# Product Errata: UT700 MIL-STD-1553 Noise Rejection Limitations

**Table 1.1 Cross Reference of Applicable Products**

Product Name:	Manufacturer Part Number	SMD #	Device Type	Internal PIC Number
UT700 LEON 3FT Microprocessor	UT700	5962-13238	All	WQ03

Figure 1.1 UT700 MIL-STD-1553 Message Error Rate vs Noise Amplitude

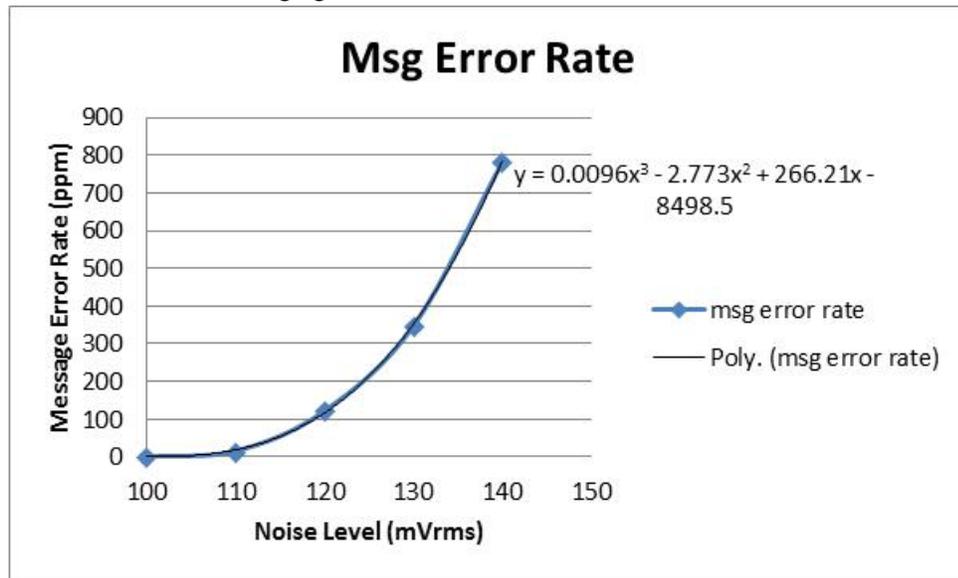
- Remote Terminal validation testing of the UT700 determined that the product passes the MIL-STD-1553 noise induced word error rate of 1E-7 at a noise amplitude of 100 mVrms. At noise levels >100 mVrms, the associate error rate increased in accordance with the plot shown in figure 21.1
- MIL-STD-1553 testing has a correlation between the message rate and the word rate, since each transfer consists of a command word and 32 data words. Because the UT700 error rate is strongly correlated to the idle time just before the command word's sync pulse and right after the final data word's parity bit, the error rate is a function of the message rate. Assuming a maximum word error rate of 1E-7 that requires a minimum of 303.03 k messages, the

maximum message error rate would be 3.3E-6. Therefore, the retry rate is expected to increase proportionally to the noise level as see in the following figure:

Designing the PCB with the least amount of skew between receiver input lines on the bus side will help minimize susceptibility to the noise, particularly at zero crossing. Part of the noise protection in a terminal relies on the filtering capabilities of the transformers, using high quality transformers will lower the susceptibility to system noise. Additionally, ensuring there are no signal, ground, or power planes beneath the transformers optimizes the transformer filtering capability.

Planning for a reduction in performance by allowing system retries for any message where the RT did not provide a response ensures the system meets the mission requirements.

Enhancing the power filtering, cable shielding, and environmental shielding can reduce the likelihood that noise will affect the system.
